Groundwater Transfer Review Summary Form

Transfer/PA # T- 14769

Application: T-14769

Applicant Name: City of Sublimity

Hydrograph

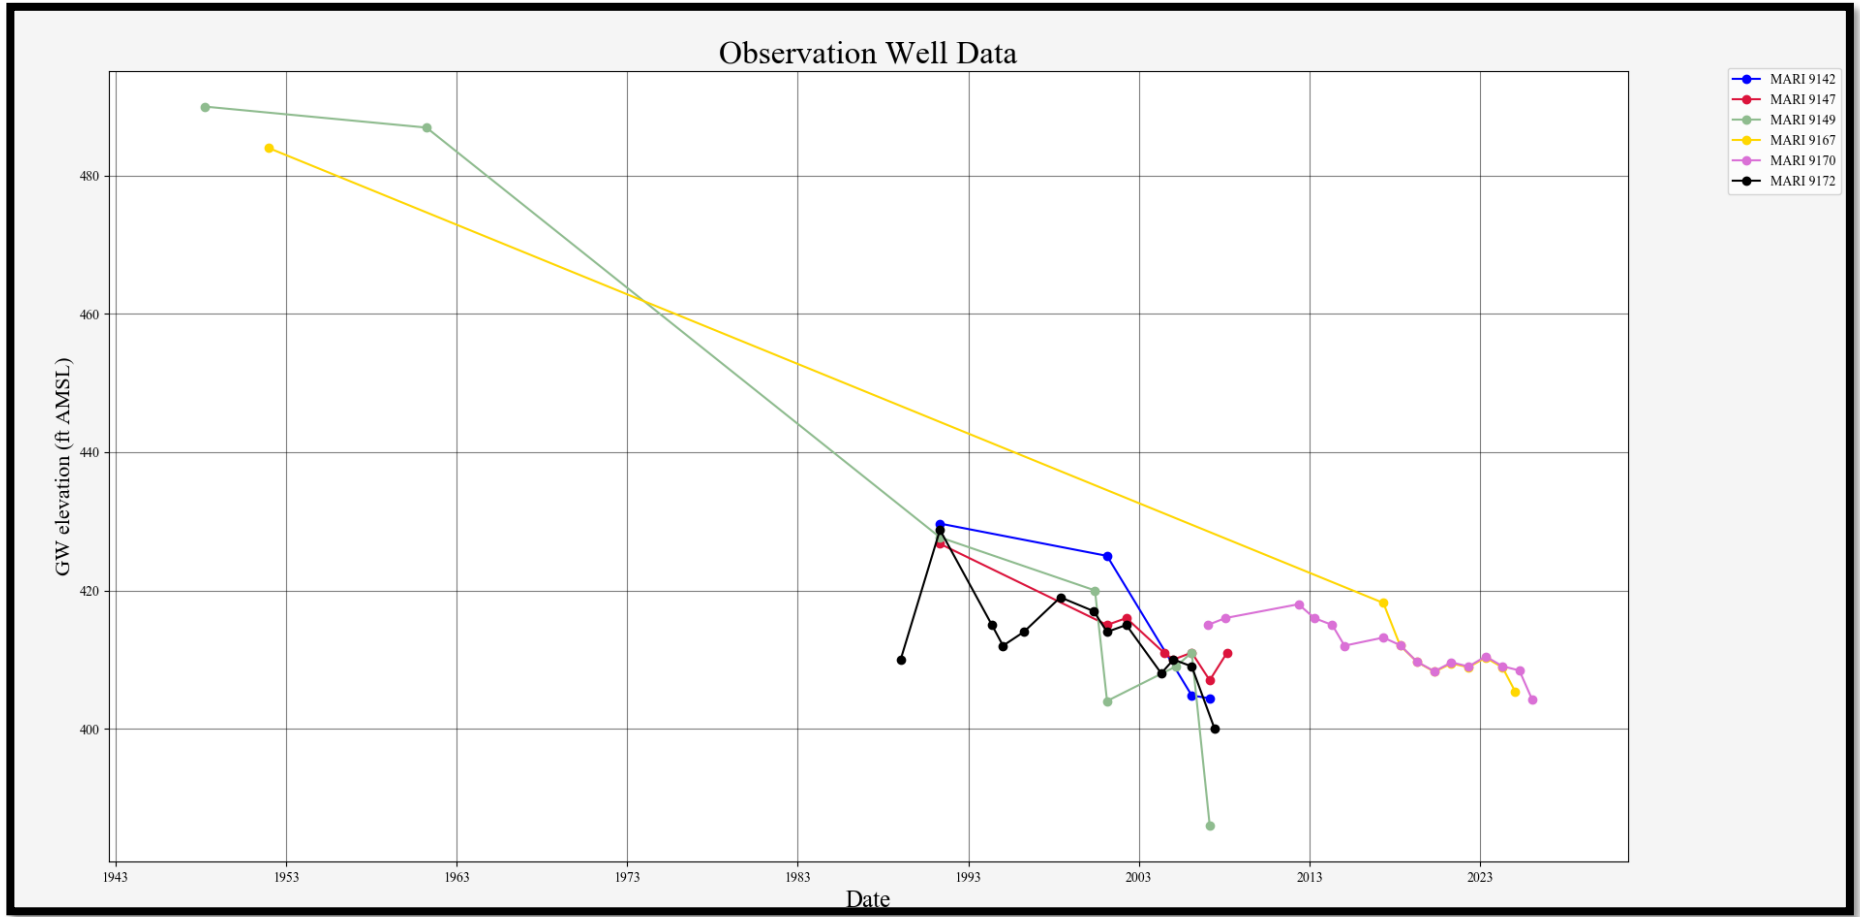
2. Will the proposed POA develop the same aquifer (source) as the existing authorized POA?
 - Yes No Comments: The authorized and proposed POAs develop groundwater from multiple water-bearing zones, WBZs, within the Columbia River Basalt Group, CRBG (Gannett and Caldwell, 1998; Woodward et al., 198). The authorized POA, POA #1 (MARI 9149), develops a WBZ from 212 to 270 ft bls [28 to 346 ft amsl] with a most recent static water level, SWL, of 155 ft bls [403 ft amsl] in 2007. The proposed APOA, Well #5 (MARI 9170/9160), develops three WBZs from 344 to 455.5 ft bls [94.5 to 206 ft amsl] with the most recent SWL of 145.83 ft bls [404.17 ft amsl] in 2026. Despite the differences in construction and elevations of WBZs, the SWLs are similar and these wells demonstrate an equilibration of WBZ heads such that the CRBG aquifer system now effectively behaves hydraulically as a single source (see attached Hydrograph). The APOA develops the same source as the authorized POA.

Theis Interference Analysis

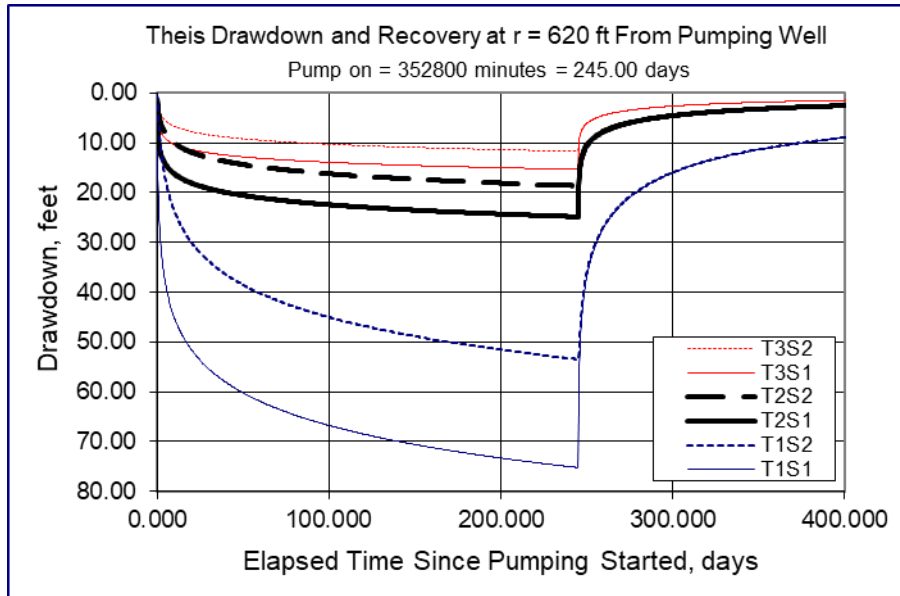
Yes No If yes, explain: The Theis (1935) solution for drawdown was used to assess the potential for injury to MARI 9166 and MARI 9167 from the proposed changes (see attached Theis Interference Analysis). Pumping by the APOA, Well#5 (MARI 9170), is not likely to result in MARI 9166 or MARI 9167 not receiving the water to which they are legally entitled.

*The max rates on the non-subject water rights could not be used for the entire irrigation season because the maximum duties would be used up. The individual duties of 22.5 AF, 0.4 AF, and 13.5 AF could be used over the 245-day irrigation season at respective average rates of 0.0463 cfs, 0.000823 cfs, and 0.027781 cfs. Adding the subject water right rate of 0.2 cfs, the combined rate used is 0.2749 cfs (123.4 gpm).

SWL	84, 83	ft bls	MARI 9166, MARI 9167
Aquifer Bottom	470	ft bls	MARI 9170
Available Water Column	386 and 387	ft	Aquifer bottom-SWL
Pump Height Above Bottom	5	ft	Estimate
NPSHa	5	ft	Estimate
Drawdown	64	ft	Estimated from MARI 9166
Minimum Water Column	74	ft	Estimated Drawdown + NPSHa + Pump Height
Injury	312 and 313	ft	Available Water Column-Minimum Water Column for MARI 9166 and MARI 9167
